From:	[redacted]
Sent:	27/01/2023 5:25:38 PM
To:	Council Northernbeaches Mailbox
Cc:	[redacted]
Subject:	Re: DA 2022 2275 103 BYNYA ROAD, PALM BEACH NSW 2108 WRITTEN SUBMISSION: LETTER OF OBJECTION SUBMISSION: TULLOCH
Attachments:	103 BYNYA PB WS.pdf;

25 JANUARY, 2023

RE: DA 2022 2275
103 BYNYA ROAD, PALM BEACH NSW 2108
WRITTEN SUBMISSION: LETTER OF OBJECTION
SUBMISSION: TULLOCH

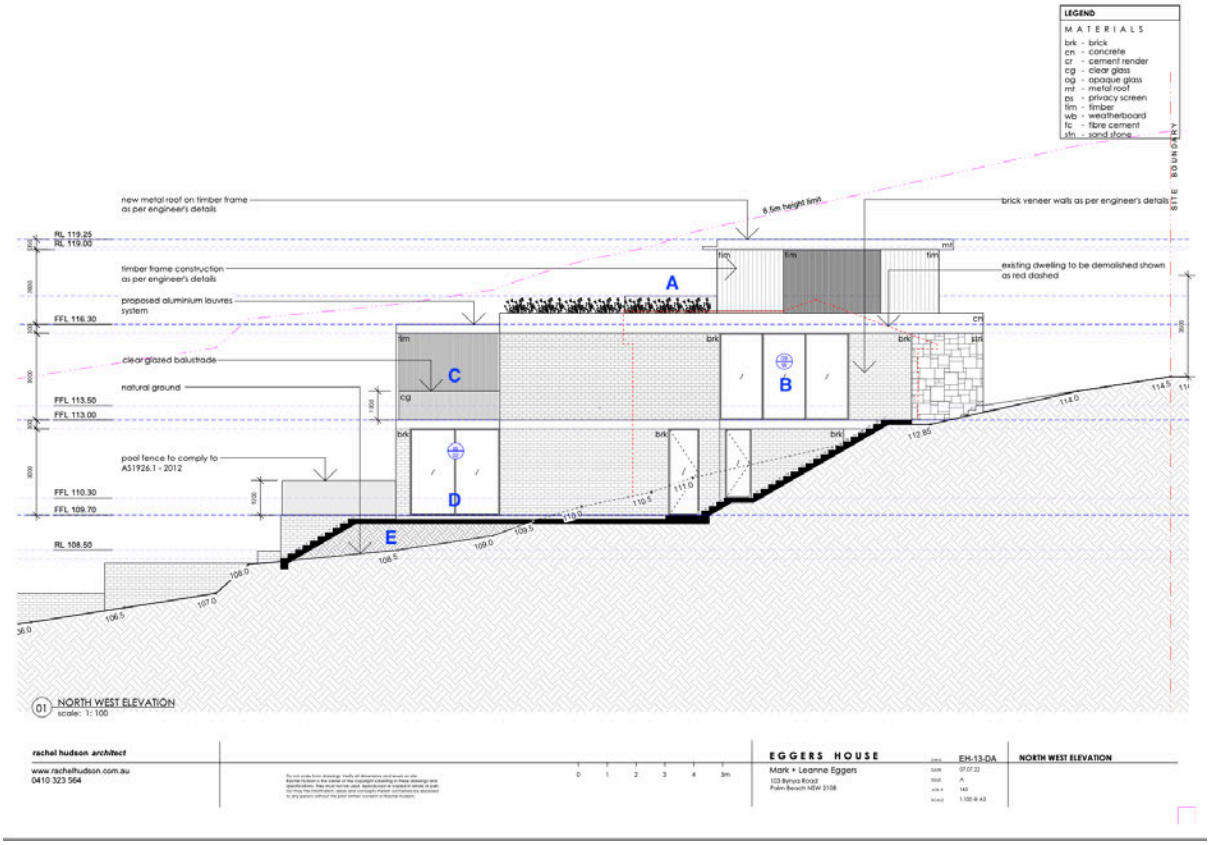
There are a number of privacy concerns:

A. The proposed deck at the upper level has no privacy screens. We ask for a 1.6m high privacy screen;
B. The large glass windows will look immediately and directly into our windows. We ask for a sill level at 1.6m, and the remainder of the glass to be fixed and obscured;
C. The full height privacy screen will remove view. We ask for a reduction to 1.6m above FFL;
D. The raised deck has no privacy screen. We ask for a 1.6m high privacy screen;
E. The raised walkway will enable residents to look over the dividing fence. We ask for the side path to follow the existing levels.

Response: The proposed development results in a privacy impact with the proposed windows facing neighbours without sufficient screening devices being provided, considering the proposed windows are directly opposite my clients' windows and balconies.

Response: The windows in question are windows of the main circulation zones and living areas, it is considered that the living areas will result in an unacceptable privacy breach. The proposed windows and decks facing the rear private open spaces for the neighbouring dwelling and will result in an unacceptable level of privacy impact.

- The full height privacy screen will remove view. We ask for a reduction to 1.6m above FFL. Privacy Screens to be shall be of fixed panels or battens or louver style construction (with a maximum spacing of 20mm), in materials that complement the design of the approved development;
